RE: SD-2021-001/ENG-2021-019/SEPA-2021-010

City of Mukilteo completed an initial review of your application and the supporting documents provided for a 7-lot subdivision located at 9110 53rd Avenue W, Mukilteo, Washington on October 8, 2021. Based on our review, the following revisions or additional information are necessary to complete our review of your project. If any of the items below are unclear to you, please do not hesitate to contact me right away so I can clarify them for you.

Figure 1 – Detention/Wet Vault "Bypass Basin" Areas as shown in yellow

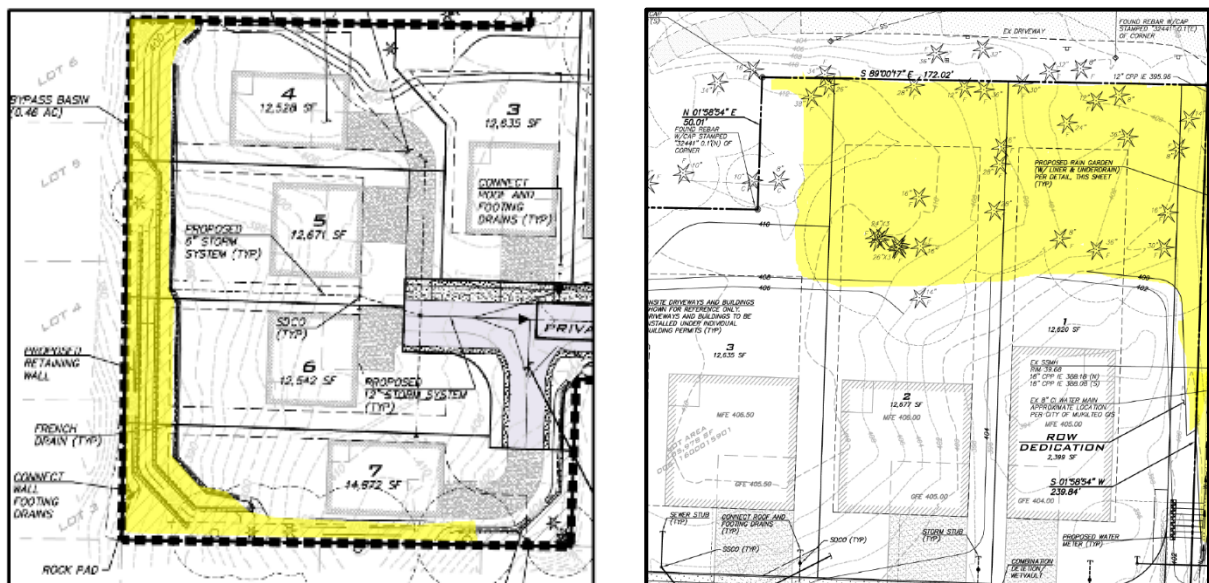
- a. 92nd Street SW *Public Comment No(s).*: (5)(6)(12)(15)
 - b. 53rd Ave drainage ditch to Smuggler's Gulch Creek *Public Comment No(s).*: (1)(5)(6)(12)(15)
3. All drainage from "Bypass Basin" areas must be evaluated for impact on water quality and quantity. *Public Comment No(s).*: (2)(3)(4)(5)(6)(7)(8)(9)(10)(11)(12)(13)(14)(15)(16)(17)
- a. Drainage west and south of the French drain to neighboring properties.
 - b. Drainage from the northeast corner of the property.
 - i. This area is shown on the November submittal as a bypass that sheet flows to the City's right-of-way. This stormwater must be accounted for within the private system. Please address stormwater from this area and update the Drainage Plan and Report. Evaluate capacity of storm systems as appropriate.
